Access Assessment Report

711 Hunter Street, Newcastle West NSW 2302

Reference No: 114499-Access-r2

Date: 17 October 2022

Pre-adaptation Stage Layout of Example Unit 1.17.01

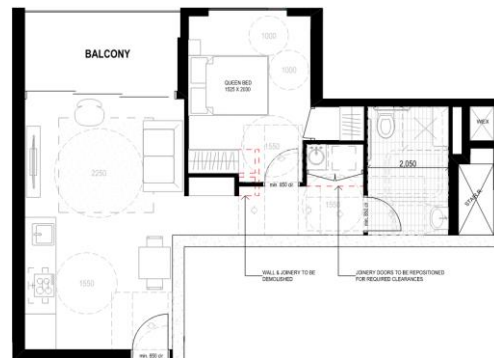
The proposed adaptation strategy for 1 Bedroom Type Adaptable SOU associated with DA Stage 1 of The Development as indicated on drawing PLA-DA-S1-6000 via example unit 1.17.01 generally involves the following minor works and modifications:

- > Adaptable Unit Entry
 - Unit entry is detailed with minimum 850mm clear opening width from pre-adaptation stage and maintained with this exact dimension and set out to post-adaptation stage.
 - Internal unit entry door circulation space can readily and easily be provided through relocating loose furniture items.
- > Adaptable Internal Corridor
 - Internal corridor appears to achieve minimum 1m in clear width and the architect will need to add all critical clear width dimensions during detailed design development stages post-DA to demonstrate compliance.
- > Adaptable Internal Doorways
 - All internal swing doorways have been detailed from pre-adaptation stage to achieve minimum 850mm clear opening width for compliance with AS1428.1-2009 and all doors are

- Overall bathroom shell of 2050mm width by approximately 3000mm in length (architect to add exact dimension for the length) appears to be identical between pre-adaptation and post-adaptation stages with exception to the nib wall associated with the vanity being demolished as part of adaptation.
- Pre-adaptation stage vanity carcass and nib wall can readily be detailed (e.g. wall on continuous vertical angles) during detailed design development stages post-DA for ease of adaptation.
- A hob-less shower has been proposed at pre-adaption stage with a glazed shower screen as means separating water from the shower wetting the adjacent toilet pan. The process of modification primarily involves the removal of the shower screen.

The proposed modification can readily meet relevant Performance Requirements of Clause 2.2 of AS4299 – 1995 subject to refining the finer details of the shower screen (e.g. screen installed on continuous vertical angles from outset) to ensure ease of adaptation whilst minimising cost and extent of works (e.g. re-tiling and re-waterproofing tiled wall and/or floor).

- A separate laundry room is not proposed. A laundry cabinet is proposed from pre-adaption stage and maintained in the same location between pre-adaptation and post-adaptation stages. The cabinetry doors can readily be modified (e.g. removed) to accommodate required minimum 1550mm clear diameter turning circle in front of laundry appliances at post-adaptation stages.

Pre-adaptation Stage Floorplan of Example Unit 1.07.06

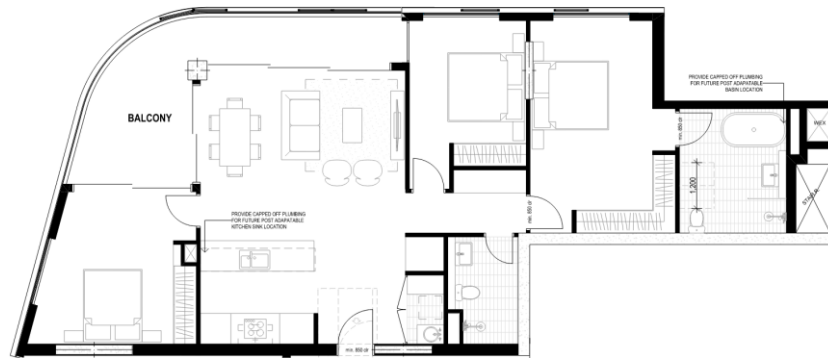
The proposed adaptation strategy for 2 Bedroom Type Adaptable SOU associated with DA Stage 1 of The Development as indicated on drawing PLA-DA-S1-6000 via example unit 1.07.06 generally involves the following minor works and modifications:

NB: It is recommended for the architect to add internal door circulation space dimensions (i.e. minimum 530mm latch-side clearance along minimum 1450mm clear depth for a frontal approach when the door swings towards the user for compliance with AS1428.1-2009) at both pre-adaptation and post-adaptation stage plans.

- Internal corridor appears to achieve minimum 1m in clear width and the architect will need to add all critical clear width dimensions during detailed design development stages post-DA to demonstrate compliance.

- Overall bathroom shell has been dimensioned to achieve 2050mm in width by 2500mm in length and the overall shell appears to be identical between pre-adaptation and post-adaptation stages.
- A hob-less shower has been proposed at pre-adaption stage with a glazed shower screen as means separating water from the shower wetting the adjacent toilet pan. The process of modification primarily involves the removal of the shower screen.

The proposed modification can readily meet relevant Performance Requirements of Clause 2.2 of AS4299 – 1995 subject to refining the finer details of the shower screen (e.g. screen installed on continuous vertical angles from outset) to ensure ease of adaptation whilst minimising cost and extent of works (e.g. re-tiling and re-waterproofing tiled wall and/or floor).

- A separate laundry room is not proposed. A laundry cabinet is proposed from pre-adaption stage and maintained in the same location between pre-adaptation and post-adaptation stages. The cabinetry doors can readily be modified (e.g. removed if and when required) to accommodate required minimum 1550mm clear diameter turning circle directly in front of laundry appliances at post-adaptation stages.

- The kitchen at pre-adaption stage consists of L-shaped bench with a cooktop and sink with a recessed area for a fridge. This layout stays exactly the same at post-adaptation stage and can accommodate minimum 1550mm clear diameter turning circle between kitchen appliances.

Pre-adaptation Stage Floorplan of Example Unit 1.18.05

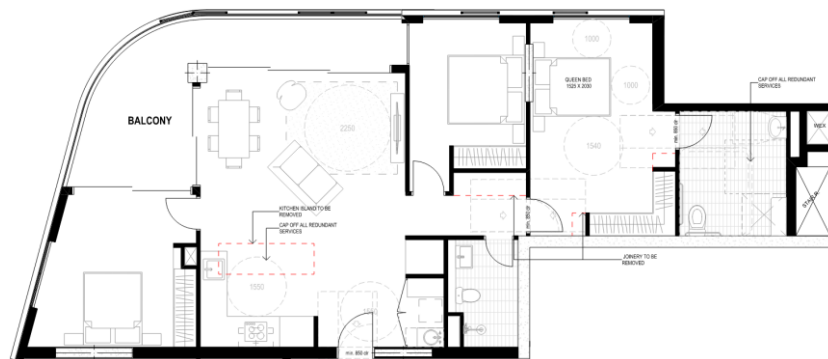
The proposed adaptation strategy for 3 Bedroom Type Adaptable SOU associated with DA Stage 1 of The Development as indicated on drawing PLA-DA-S1-6001 via example unit 1.18.05 generally involves the following minor works and modifications:

NB: It is recommended for the architect to add internal door circulation space dimensions (i.e. minimum 530mm latch-side clearance along minimum 1450mm clear depth for a frontal approach when the door swings towards the user for compliance with AS1428.1-2009) at both pre-adaptation and post-adaptation stage plans.

- Internal corridor appears to achieve minimum 1m in clear width and the architect will need to add all critical clear width dimensions during detailed design development stages post-DA to demonstrate compliance.

- Adaptable bathroom's shell appears to be sufficient in overall room dimensions (architect to add exact dimensions in terms of width and length) and identical between pre-adaptation and post-adaptation stages.
- The pre-adaption stage bathroom has a vanity with inbuilt basin and a free-standing bathtub that is provided from outset. These sanitaryware are removed as part of the process of adaptation allowing the resident to install an accessible basin for compliance with AS1428.1-2009 without encroaching into required minimum circulation spaces for the shower recess and toilet pan.

- A hob-less shower has been proposed at pre-adaption stage with a glazed shower screen as means separating water from the shower wetting the adjacent basin. The process of modification primarily involves the removal of the shower screen and the re-orientation of the shower.

The proposed modification has the potential to meet relevant Performance Requirements of Clause 2.2 of AS4299 – 1995 subject to refining the finer details of the shower screen (e.g. glass screen enclosure and swing door installed on continuous vertical angles from outset) to ensure ease of adaptation whilst minimising cost and extent of works (e.g. re-tiling and re-waterproofing tiled wall and/or floor) and provision of capped off services from outset for the shower re-orientation to comply with AS1428.1-2009 at post-adaptation stage.

- A separate laundry room is not proposed. A laundry cabinet is proposed from pre-adaption stage and maintained in the same location between pre-adaptation and post-adaptation stages. The cabinetry doors can readily be modified (e.g. removed if and when required) to accommodate required minimum 1550mm clear diameter turning circle directly in front of laundry appliances at post-adaptation stages.

At post-adaption stage the kitchen is modified to be a continuous L-shaped bench with the sink relocated to accommodate minimum 1550mm clear diameter turning circle in front of the sink and cook top.

Pre-adaptation Stage Floorplan of Example Unit 2.01.01

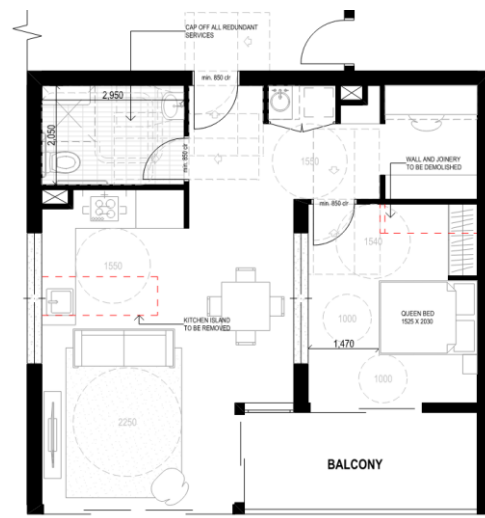
The proposed adaptation strategy for 1 Bedroom Type Adaptable SOU associated with DA Stage 2 of The Development as indicated on drawing PLA-DA-S2-6000 via example unit 2.01.01 generally involves the following minor works and modifications:

NB: It is recommended for the architect to add internal door circulation space dimensions (i.e. minimum 530mm latch-side clearance along minimum 1450mm clear depth for a frontal approach when the door swings towards the user for compliance with AS1428.1-2009) at both pre-adaptation and post-adaptation stage plans.

- Internal corridor appears to achieve minimum 1m in clear width and the architect will need to add all critical clear width dimensions during detailed design development stages post-DA to demonstrate compliance.

- Overall bathroom shell has been dimensioned to achieve 2050mm in width by 2950mm in length and the overall shell appears to be identical between pre-adaptation and post-adaptation stages.
- A hob-less shower has been proposed at pre-adaption stage with a glazed shower screen as means separating water from the shower wetting the toilet pan. The process of modification primarily involves the removal of the shower screen.

The proposed modification can readily meet relevant Performance Requirements of Clause 2.2 of AS4299 – 1995 subject to refining the finer details of the shower screen (e.g. glass screen continuous vertical angles from outset) to ensure ease of adaptation whilst minimising cost and extent of works (e.g. re-tiling and re-waterproofing tiled wall and/or floor).

- A separate laundry room is not proposed. A laundry cabinet is proposed from pre-adaption stage and maintained in the same location between pre-adaptation and post-adaptation stages. The cabinetry doors can readily be modified (e.g. removed if and when required) to accommodate required minimum 1550mm clear diameter turning circle directly in front of laundry appliances at post-adaptation stages.

- The kitchen at pre-adaption stage consists of two (2) separate parallel benches with a cooktop on one bench and a sink on the remaining bench with a recessed area for a fridge. There are provisions for capped off plumbing services from outset for future sink relocation.

At post-adaption stage the kitchen is modified to be a continuous L-shaped bench with the sink relocated to accommodate minimum 1550mm clear diameter turning circle in front of the sink and cook top.

Pre-adaptation Stage Floorplan of Example Unit 2.14.05

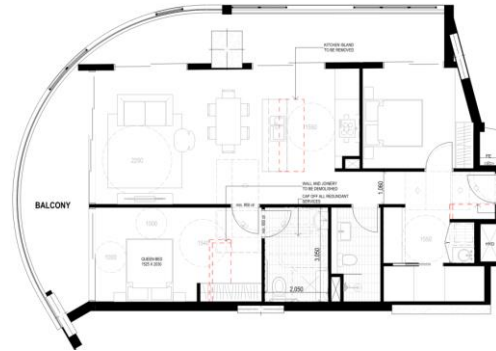
The proposed adaptation strategy for 2 Bedroom Type Adaptable SOU associated with DA Stage 2 of The Development as indicated on drawing PLA-DA-S2-6001 via example unit 2.14.05 generally involves the following minor works and modifications:

- Unit entry doorway is detailed with minimum 850mm clear opening width from outset and maintained to post-adaptation stage.
- Post-adaptation stage modification will involve demolition of light construction wall and joinery item to accommodate the required internal door circulation space when the door swing towards the user for compliance with AS1428.1-2009.

- Overall bathroom shell has been dimensioned to achieve 2050mm in width by 2950mm in length and the overall shell appears to be identical between pre-adaptation and post-adaptation stages.
- A hob-less shower has been proposed at pre-adaption stage with a glazed shower screen as means separating water from the shower wetting the toilet pan. The process of modification primarily involves the removal of the shower screen.

The proposed modification can readily meet relevant Performance Requirements of Clause 2.2 of AS4299 – 1995 subject to refining the finer details of the shower screen (e.g. glass screen continuous vertical angles from outset) to ensure ease of adaptation whilst minimising cost and extent of works (e.g. re-tiling and re-waterproofing tiled wall and/or floor).

- A separate laundry room is not proposed. A laundry cabinet is proposed from pre-adaption stage and maintained in the same location between pre-adaptation and post-adaptation stages. The cabinetry doors can readily be modified (e.g. removed if and when required) to accommodate required minimum 1550mm clear diameter turning circle directly in front of laundry appliances at post-adaptation stages.

- Due to the open plan of the living area, loose furniture items can readily and easily be relocated to accommodate minimum 2250mm clear diameter turning circle as required.
